UNITED STATES PATENT AND TRADEMARK OFFICE

APPLICATION NO.	FILING DATE	FIRST NAMED INVENTOR	ATTORNEY DOCKET NO.	CONFIRMATION NO.
10/644,650	08/20/2003	Timothy A. Skunes	C34.12-0058	5482

Office Action Summary

DETAILED ACTION

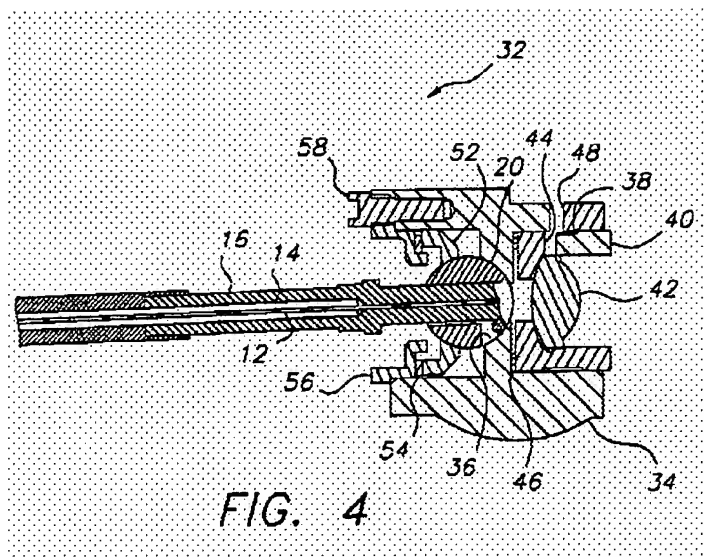
Regarding claim 1, Frelier discloses an optical alignment mount for adjusting a height of an optical component relative to a substrate (see Figure 4, reproduced below) comprising:

a component mount **20** adapted to receive an optical component **12**, the component mount having a pivot surface; and

a pivot support **34** configured to engage the pivot surface of the component mount **20** to change the height of the optical component **12** relative to the substrate (**40/64**).

Regarding claim 2, the pivot support **34** includes a **socket 36**.

Regarding claim 5, the **socket 36** comprises a hole for allowing light to pass through.

Regarding claim 6, the component mount **20** is a spherical ball.

Regarding claim 7, wherein the hole of socket 36 is chamfered to allow component mount 20 to swivel.

Regarding claim 12, light which interacts with the optical component **12** is directed generally parallel to a plane of the substrate (40/64) as seen in Figure 4 and/or Figure 6.

Regarding claim 13, the light couples to another optical component **42** mounted to the substrate (40/64) .

Regarding claims 14, 17, 18, 20-22, and 24-26, the previous remarks are incorporated herein. It is further noted that the center of component mount **20** of Frelier may be considered a center of curvature and defined as a pivot point.

Regarding claim 27, Frelier also discloses an optical alignment mount for adjusting a height of an optical component **12** relative to a substrate comprising:

an optical component mount **34** adapted to receive an optical component **12** and further having a **socket 36**; and

a pivot support **20** with a curved pivot surface configured to engage the **socket 36** of the optical component **34** to change the height of the optical component **12** relative to the substrate (40/64).
